DATE: January 30, 2026

ADDENDUM NO. 4

PROJECT NO. DGS C-0946-0012 PHASE 006
PROJECT TITLE - PA State Museum & PHMC Tower - Infrastructure Upgrades and Renovations
PROFESSIONAL:
Design Resources Group Architects AIA
270 Davidson Ave, Suite 303
Somerset, NJ, 08873

DRAWN BY	DATE	DRAWING NUMBER
KEH	10/10/2025	MD104
CHECKED BY	SCALE	
DC	1/8" = 1'-0"

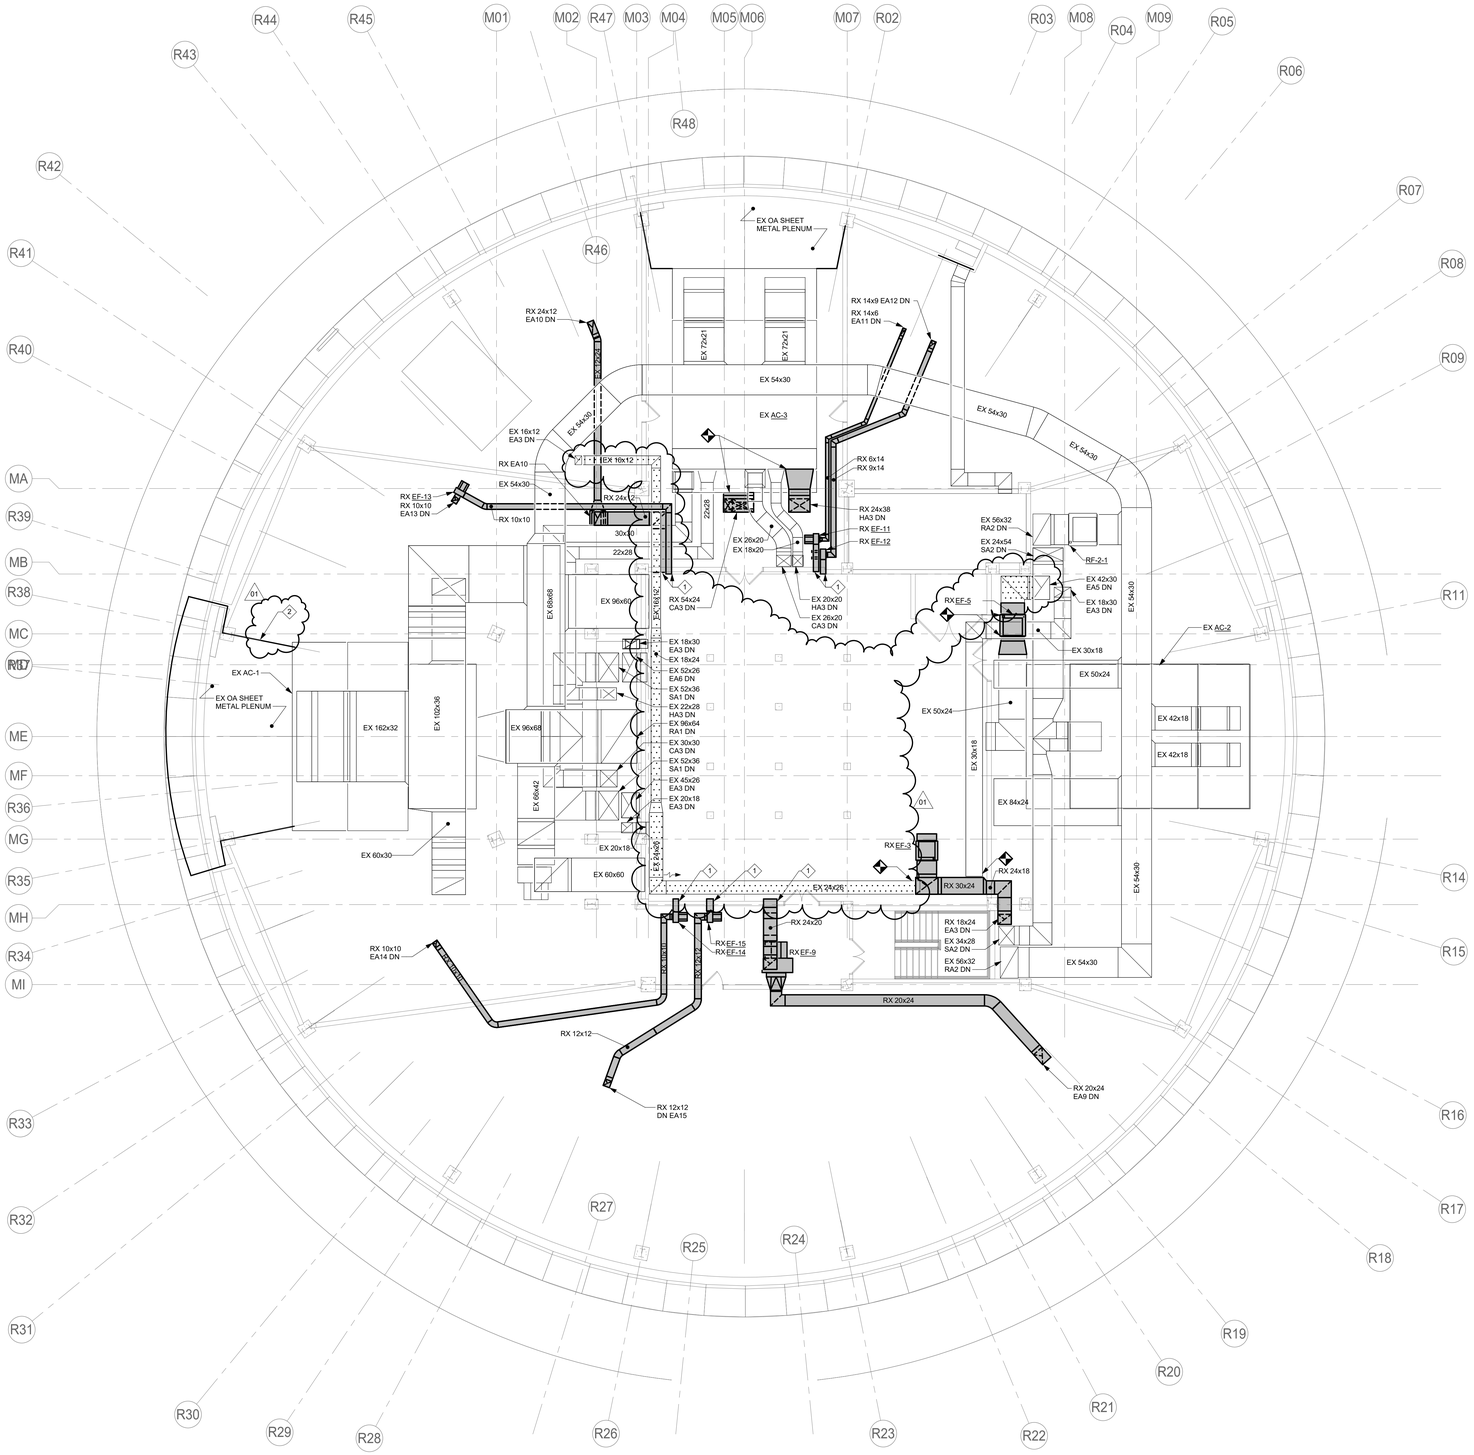
Item 67 - Drawing MD104 - Showed the extent of existing ductwork to be cleaned.

Item 68 - Drawing MD104 - Added locations where existing ceiling air devices are required to be removed under Base Bid 3.

DRAWN BY: KEH	DATE: 10/10/2025	DRAWING NUMBER: MD106
CHECKED BY: DC	SCALE: 1/8" = 1'-0"

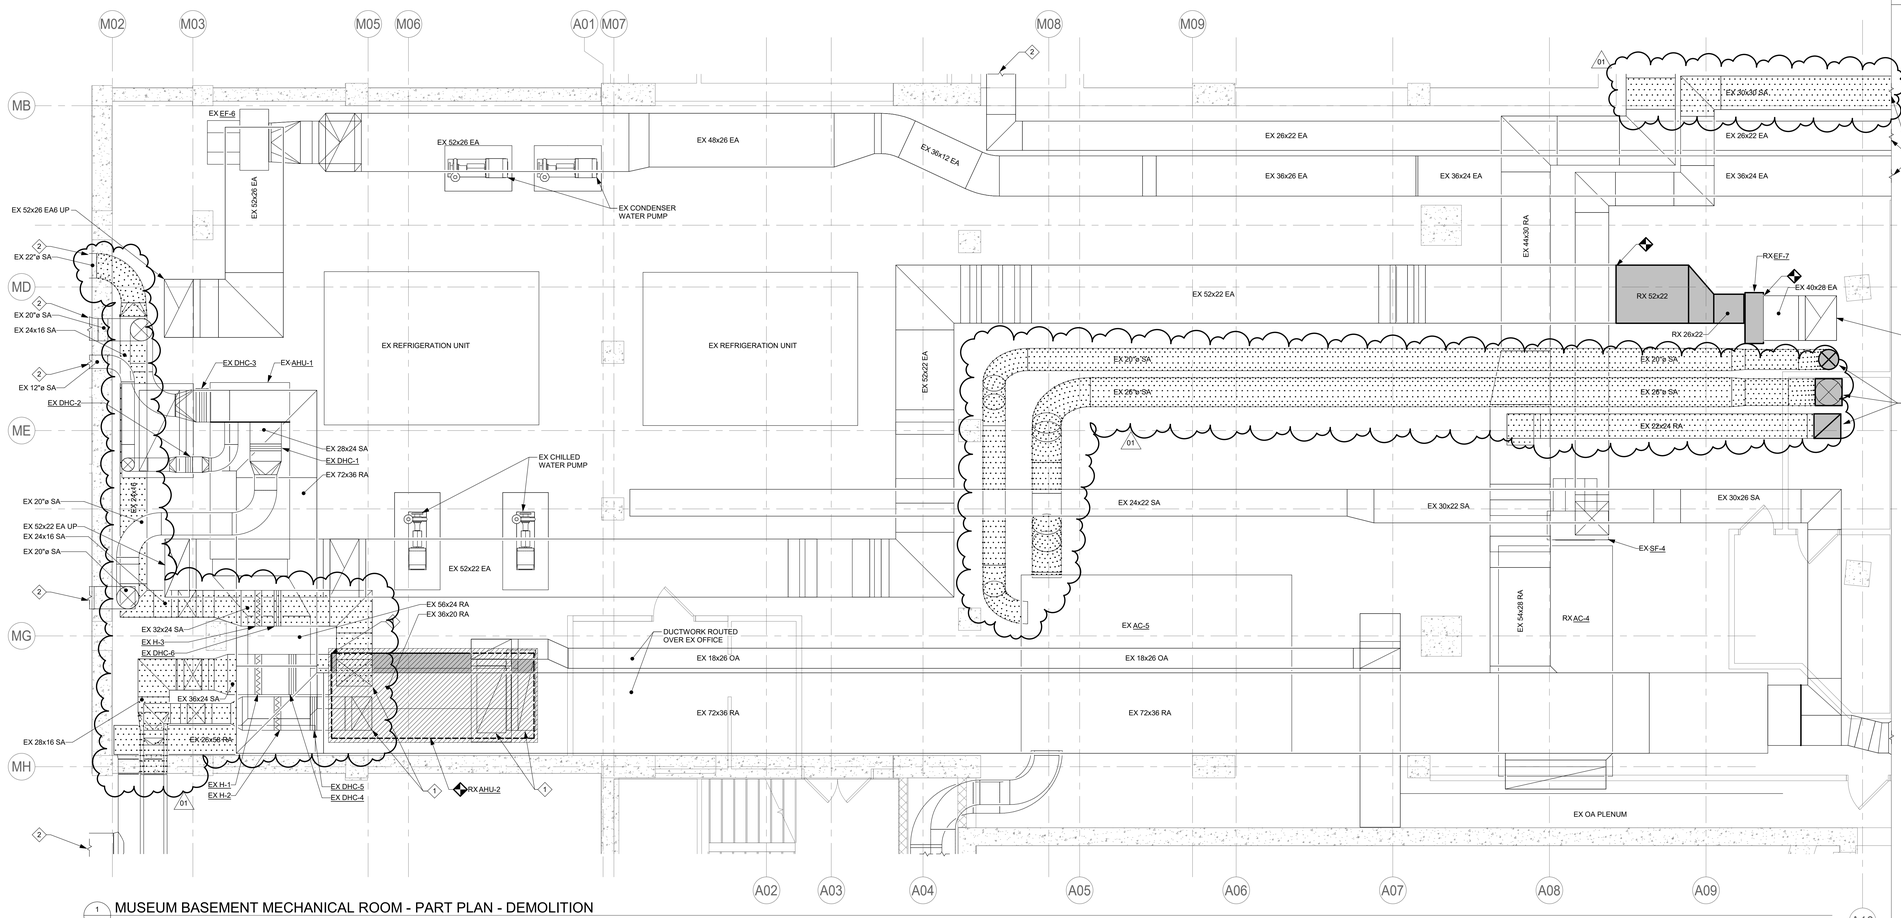
Item 69 - Drawing MD106 - Showed the extent of existing ductwork to be cleaned.

Item 70 - Drawing MD106 - Added Key Note No. 2 regarding modification of plenum wall to allow for duct penetration through the floor.

1 MD402 MUSEUM BASEMENT MECHANICAL ROOM - PART PLAN - DEMOLITION

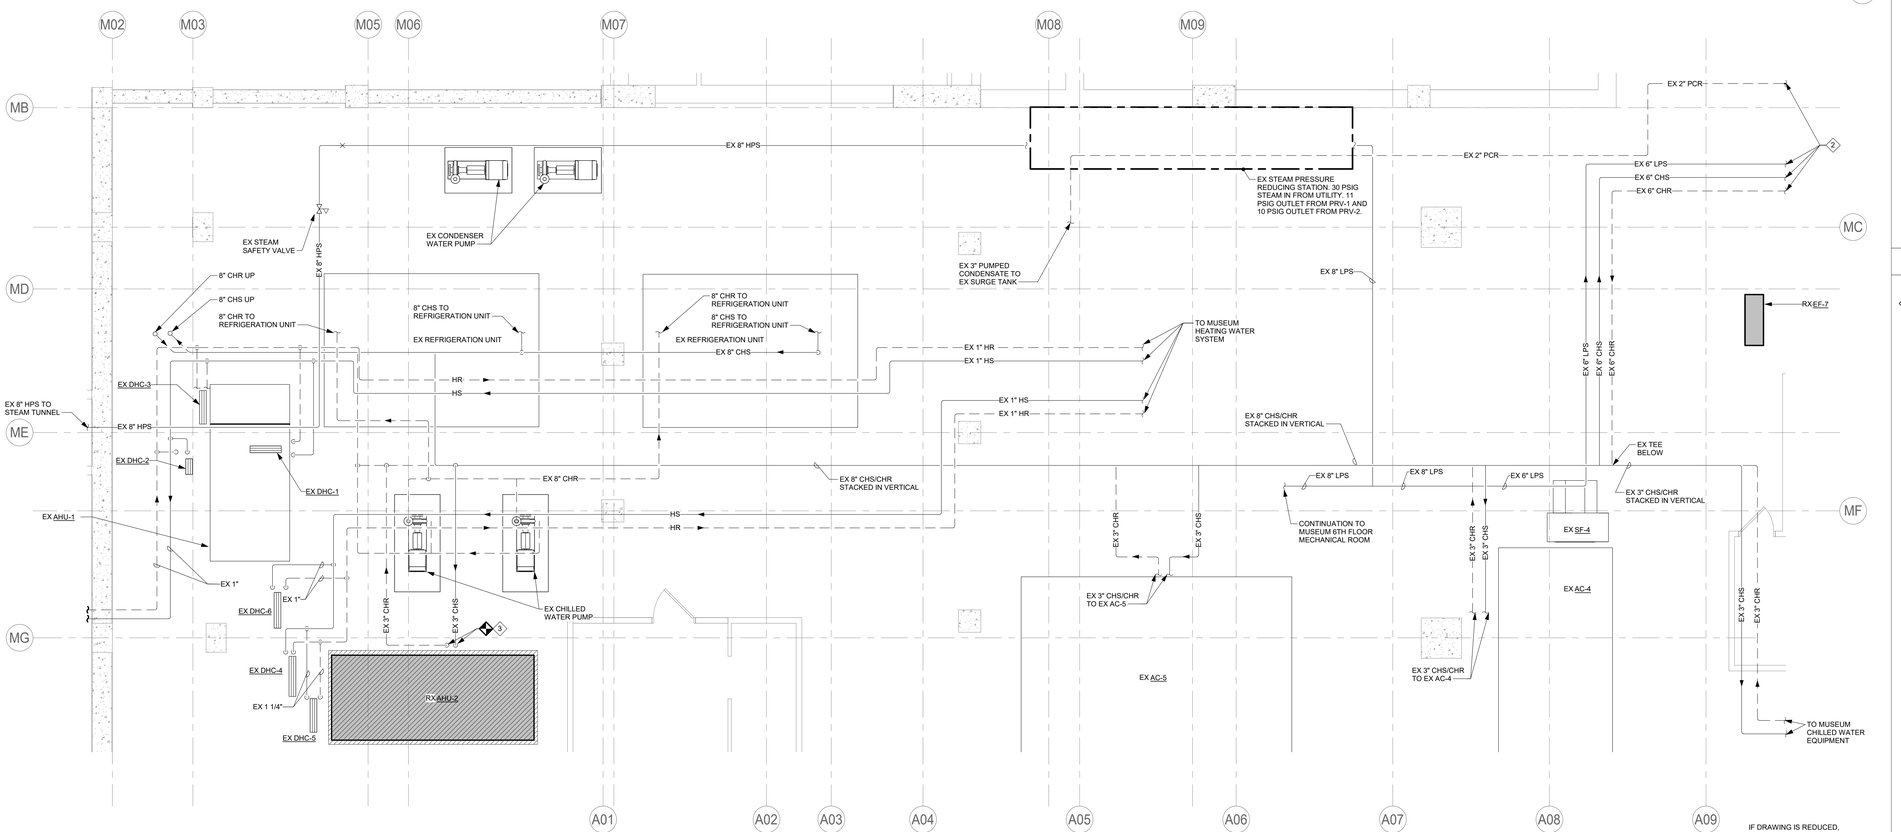
Item 71 - Drawing MD402 - Showed extent of existing ductwork to be cleaned.

1 M106 DUCTWORK PLAN - MUSEUM - SIXTH FLOOR
1/8" = 1'-0"

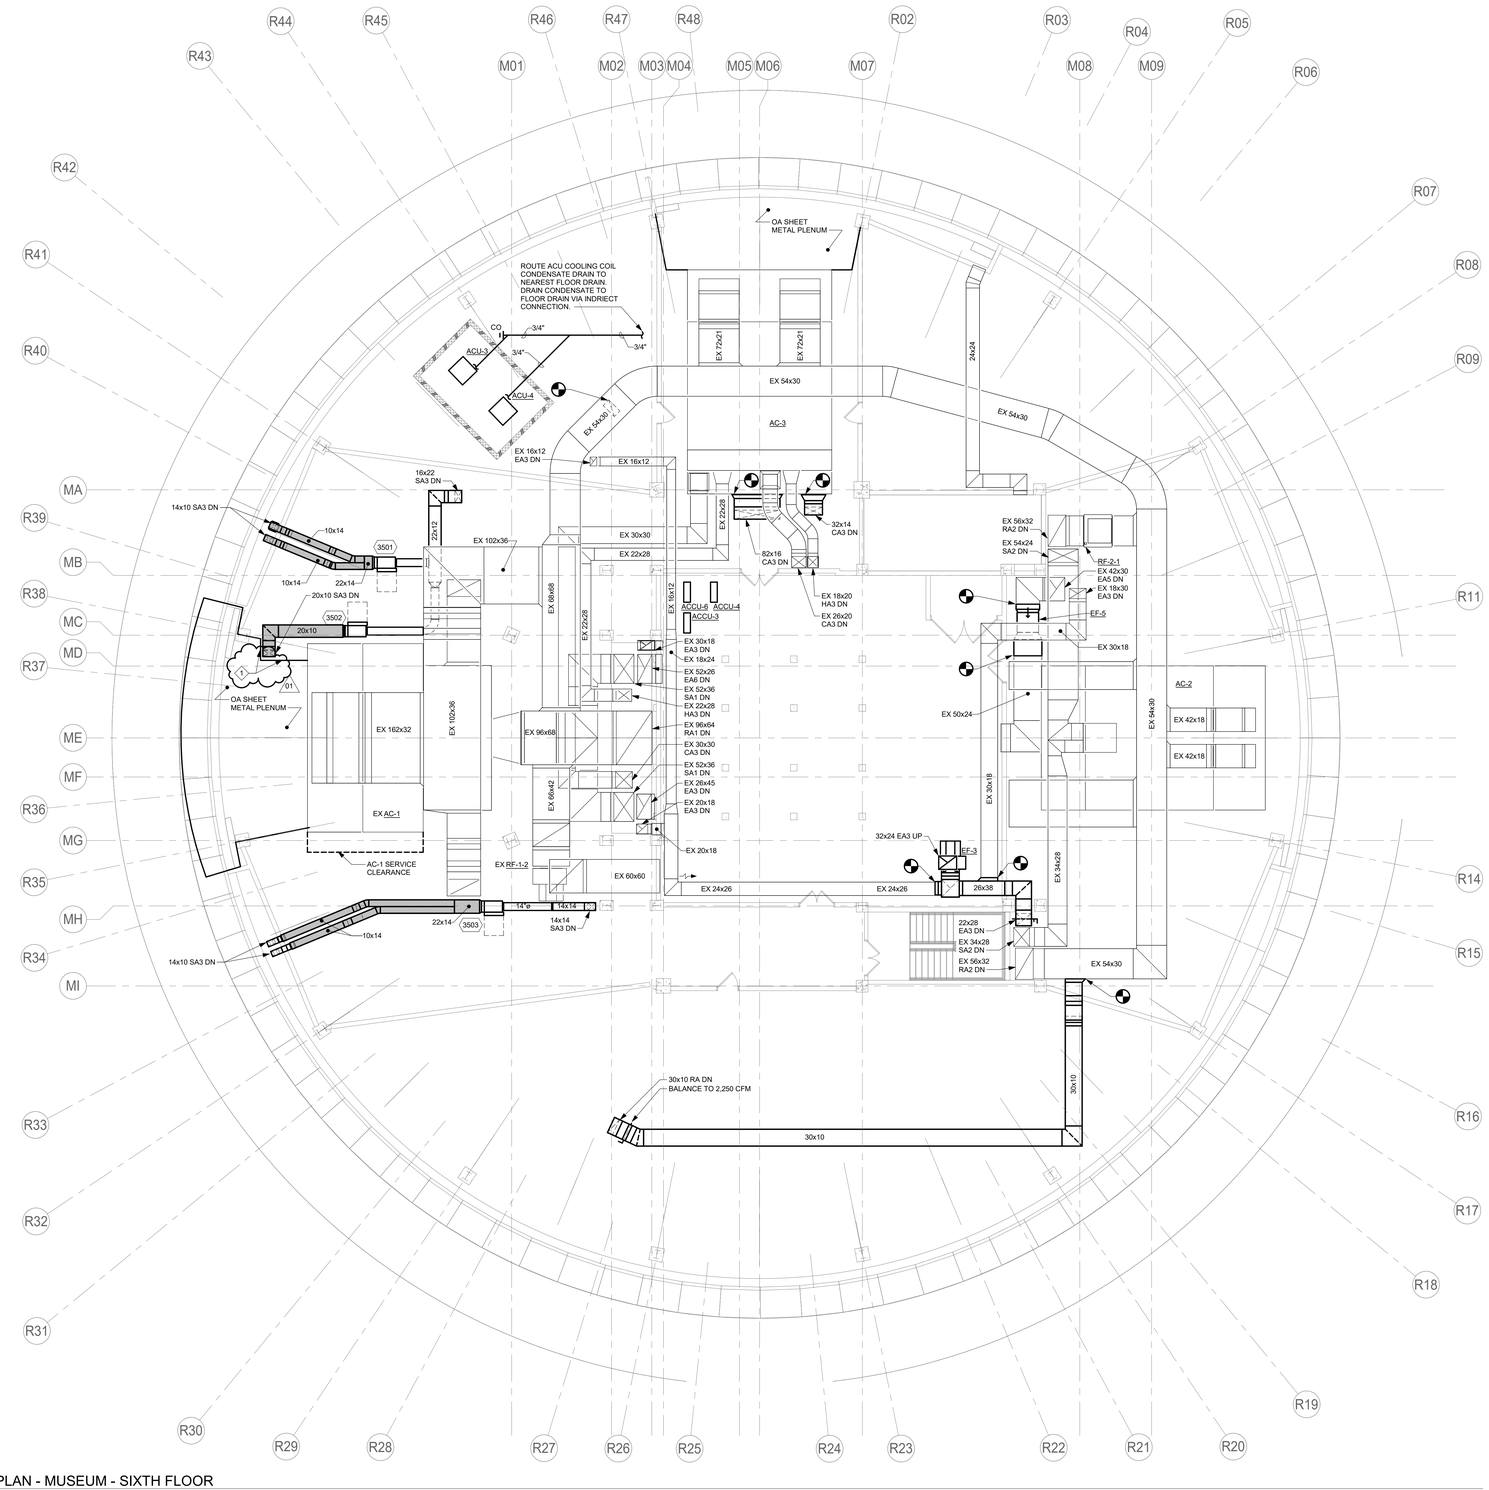
Item 77 - Drawing M106 - Added Key Note No. 1 requiring modifications of sheet metal plenum to permit installation of new ductwork (Base Bid).

DRAWN BY	DATE	DRAWING NUMBER
KEH	10/10/2025	M220
CHECKED BY	SCALE	
DC	1/8" = 1'-0"

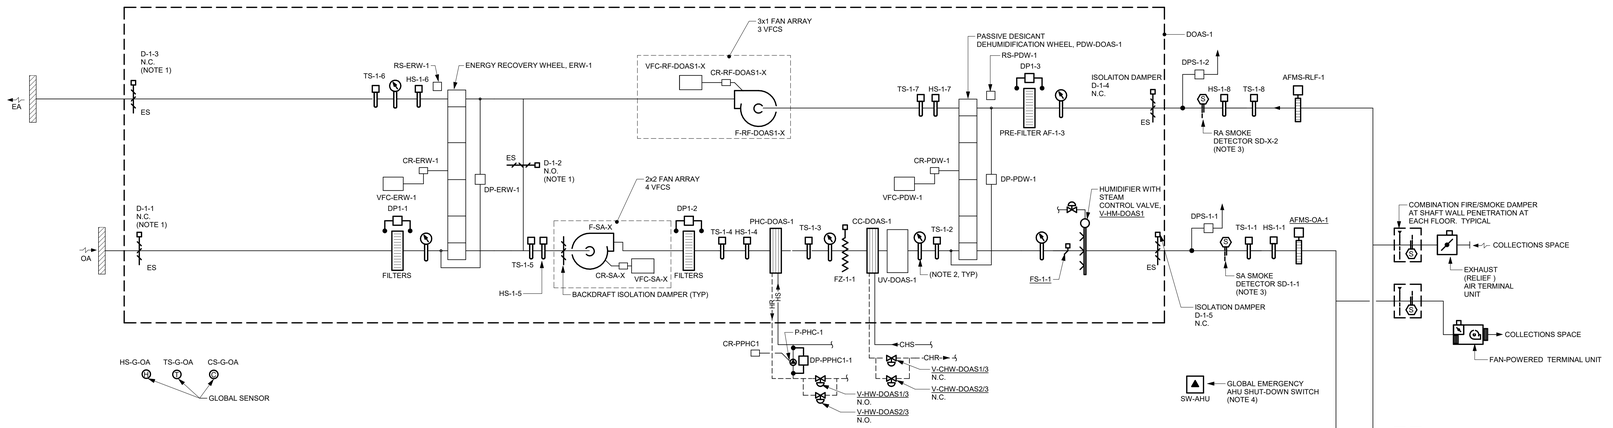
Item 78 - Drawing M220 - Deleted Plan 5 HVAC Piping Tower Level 14 Collections.

Item 79 - Drawing M220 - Relabeled Plan 3 to HVAC Piping Typical Tower Level 1 - 14 Collections.

Item 80 - Drawing M220 - Added note at Plan 3 reading: Exceptions for the vestibule layout for Levels 6, 7 and 14, with respect to IT closets, refer to Sheet M04 for enlarged Level 6 plan and Sheet M409 for enlarged Level 14 plan. Systems outside of the vestibule remain typical for each floor.

Item 81 - Drawing M220 - Added Key Note No. 4.
